SYSTEM/PROJECT/PRODUCT: Helios

## HELIOS COMPATIBILITY

Issue	Change Ref	Date
1	-	25/03/2002
2	TS001076	18/07/2002
3	TS001142	11/02/2003
4	TS002501	04/05/2005

**Top Aspect and Plastic Mounting Brackets**

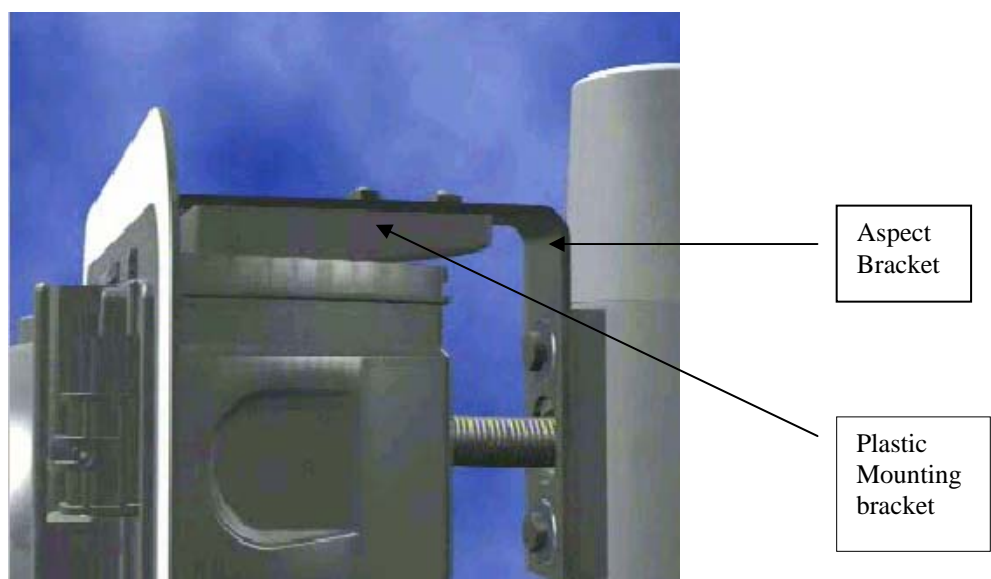
Early 1 aspect, 2 aspect and 3 aspect brackets were made of 5mm material and along with the 4 aspect mounting bracket had an 18mm slot for connecting to the plastic head mounting brackets (667/2/30052/003). Later 1 aspect, 2 aspect and 3 aspect brackets were made of 6mm material and the slot for connecting to the plastic head mounting brackets was reduced to 11mm for the 1, 2, 3 and 4 aspect brackets. Along with this change the plastic mounting brackets were changed. If an original bracket requires changing, then both the aspect bracket and the plastic mounting bracket need changing.
